ADDENDUM #1

to the REQUEST FOR PROPOSALS FOR SURVEILLANCECAMERA SYSTEM

RFP Bid No.20/21-0002

ROSEMEAD SCHOOL DISTRICT

SHUEY E.S. SITE PLAN

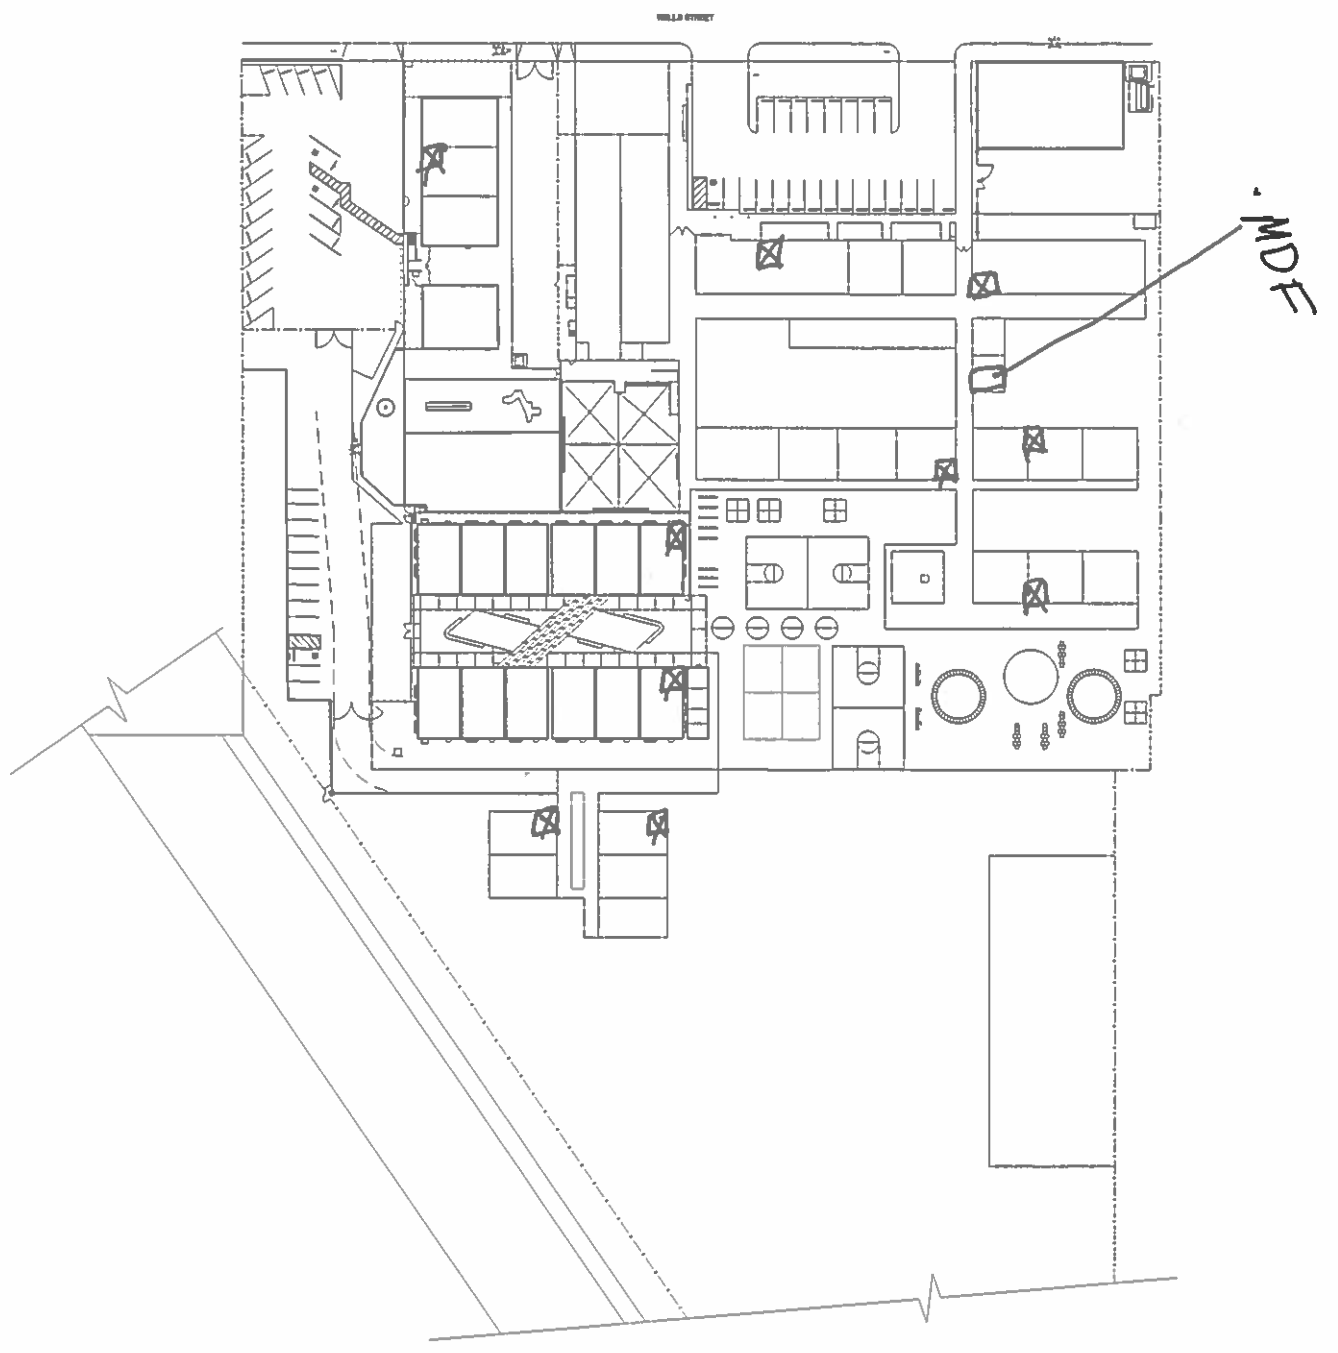
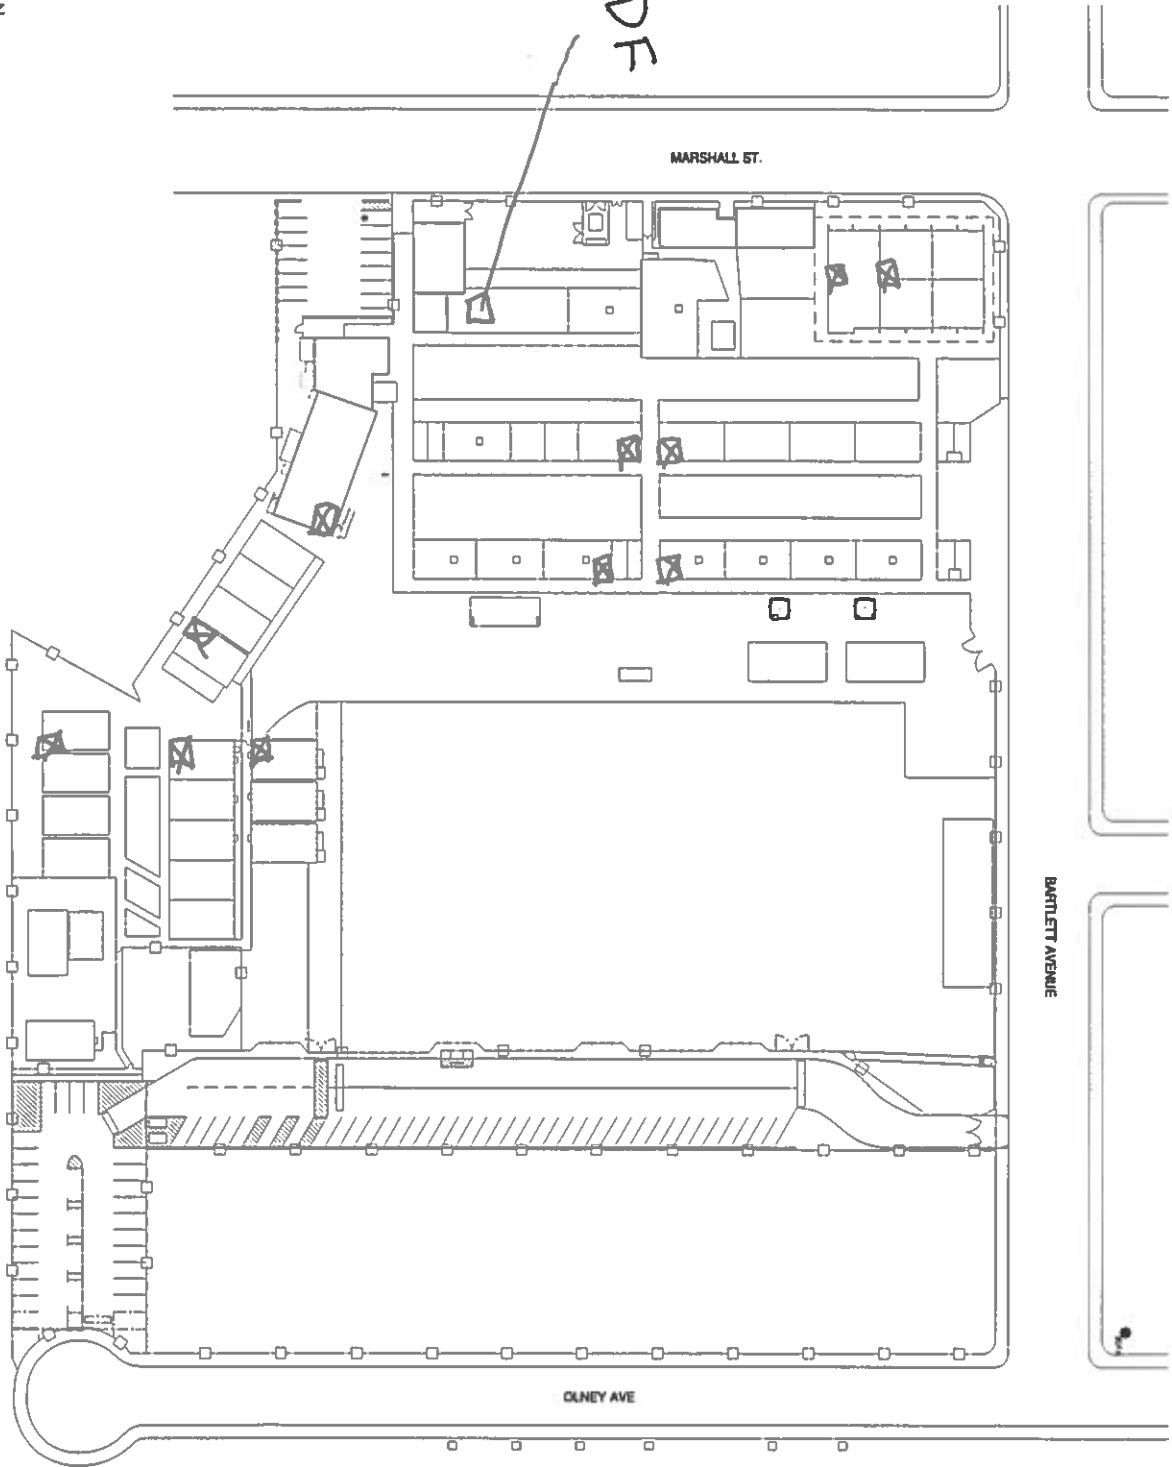
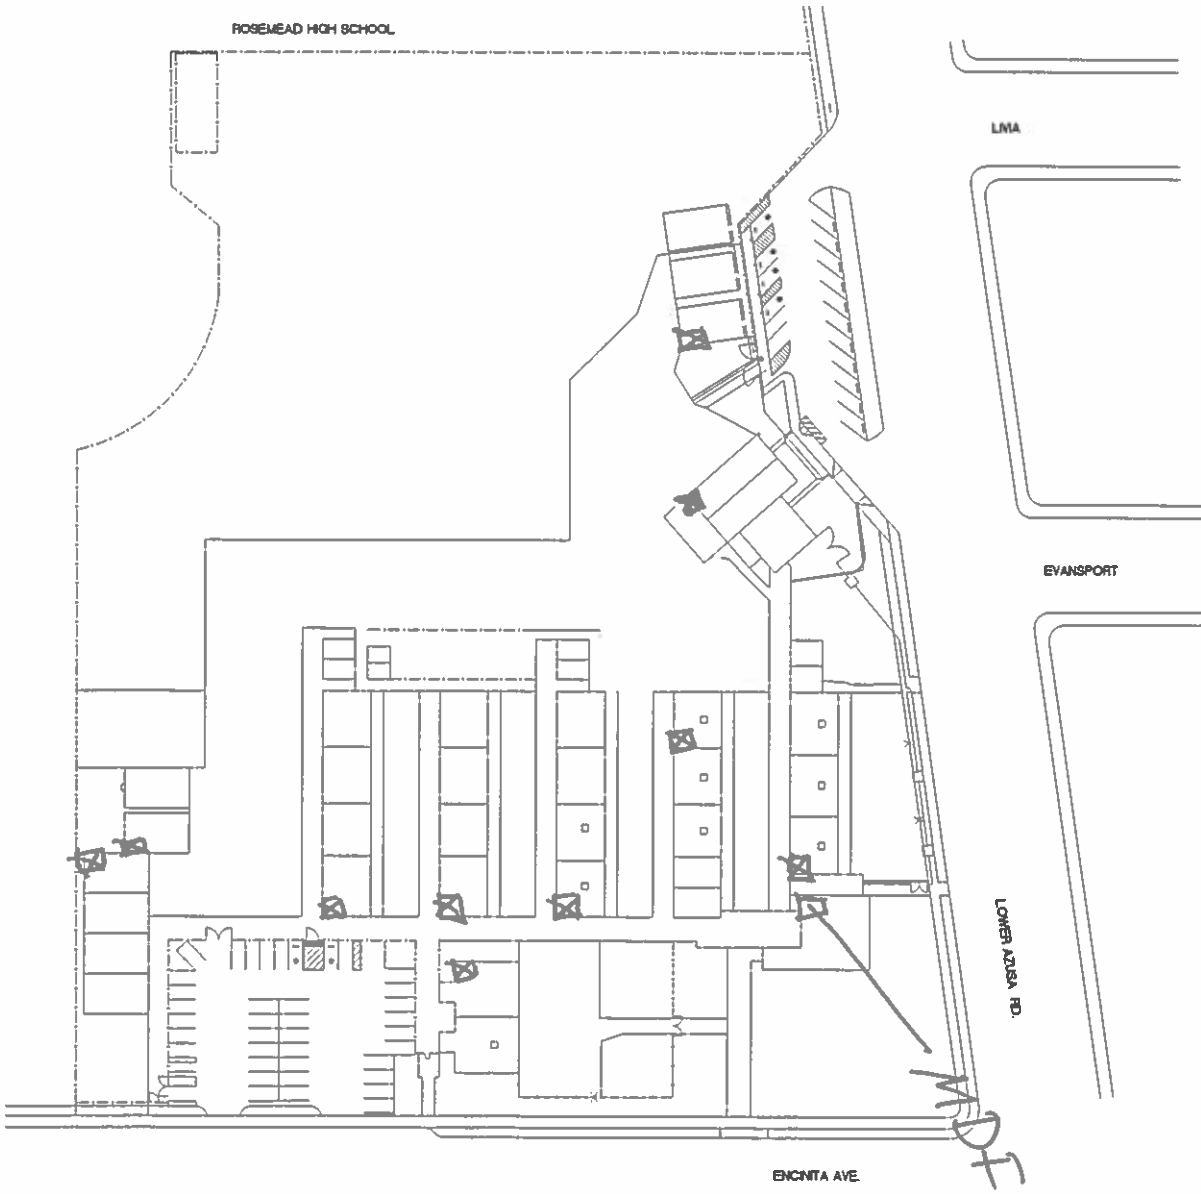
- E. The camera location site plans attached to the original RFP are replaced by the camera location site plans attached to this Addendum. All cameras (with two exceptions) are now to be attached to buildings. Exception #1 is at the northwest corner of Muscatel which will require a new pole for mounting and trenching for new power and signal. Exception #2 is at the east side of Janson where the camera will be mounted on an existing light pole using existing power.
- F. Also attached to this Addendum are site plans showing the locations of the MDF and IDFs.
- G. Clarification Questions have been received and the responses to these questions are provided below. Questions have been edited or reworded as needed for clarity, and when/if applicable, multiple questions on the same subject have been combined. Questions are numbered. **Responses follow each question in bold.**
